APPLICATION NO.	FILING DATE	FIRST NAMED INVENTOR	ATTORNEY DOCKET NO.	CONFIRMATION NO.
10/509,757	09/30/2004	Yuichi Terada	DK-US020721	8137
22919 7590 01/05/2009 GLOBAL IP COUNSELORS, LLP 1233 20TH STREET, NW, SUITE 700 WASHINGTON, DC 20036-2680				
EXAMINER				
CORRIGAN, JOSEPH JAMES				
ART UNIT		PAPER NUMBER		
3744				
MAIL DATE		DELIVERY MODE		
01/05/2009		PAPER

Office Action Summary

DETAILED ACTION

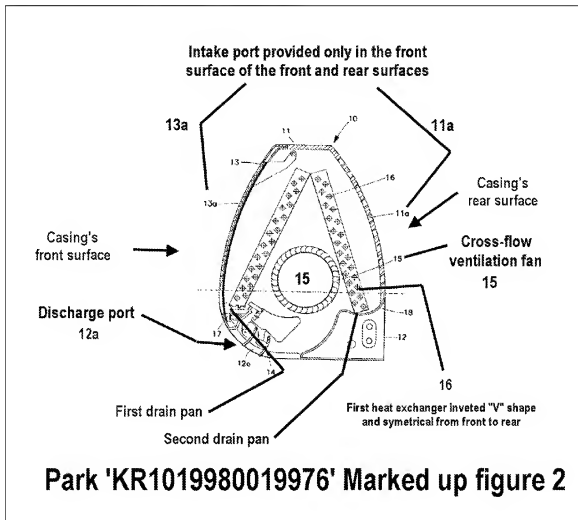
In re claims 1 and 3, King discloses an indoor unit of an air conditioner comprising: a casing having a front surface, a rear surface, a discharge port 12a and an intake port 11a, 13a provided only in the front surface of the front and rear surfaces; a ventilation fan 15 disposed in the casing to rotate about a

rotation axis, the ventilation fan being a cross flow fan that is arranged to blow air in a direction perpendicular to the rotation axis out of the discharge port of the casing; and a heat exchanger 16 disposed in the casing of the indoor unit so as to cover the ventilation fan, the heat exchanger 16 including a first heat exchange unit 16 having an approximate inverted V shape in cross-section, symmetrical from front to back (see marked up figure 2 of Park); however, Park fails to explicitly recite a second heat exchange unit that is connected at an angle with one end of the first heat exchange unit, and a third heat exchange unit that is connected at an angle with another end of the first heat exchange unit, the second heat exchange unit and the third heat exchange unit respectively extend downward from respective front and rear lower ends of the first heat exchange unit and the second heat exchange unit and the third heat exchange unit have approximately the same length.

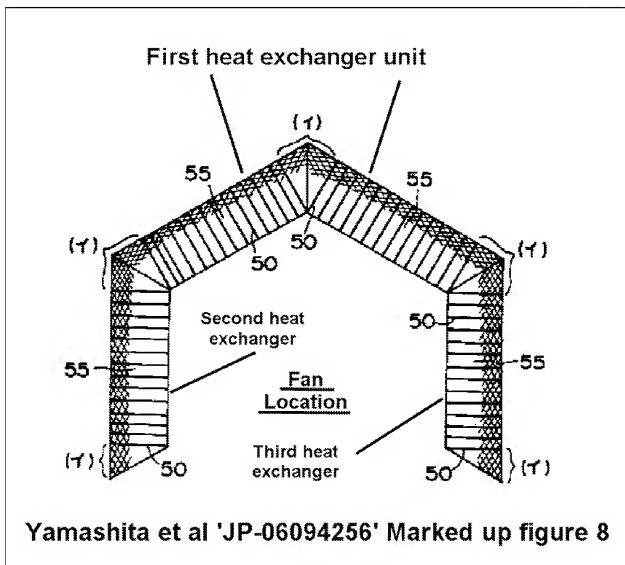
Yamashita et al teach a second heat exchange unit that is connected at an angle with one end of the first heat exchange unit, and a third heat exchange unit that is connected at an angle with another end of the first heat exchange unit, the second heat exchange unit and the third heat exchange unit respectively extend downward from respective front and rear lower ends of the first heat exchange unit and the second heat exchange unit and the third heat exchange unit have approximately the same length and symmetrical from front to back (see marked up figure 8 of Yamashita et al.)

Therefore, it would have been obvious to one of ordinary skill in the art at the time of the invention was made to modify King with four-section inverted V-shaped heat exchanger symmetrical from front to rear in a surrounding fashion as taught by Yamashita et al in order to advantageously draw air at right angles through the heat exchanger allowing for less resistance through its fins, and thereby, conserving energy.
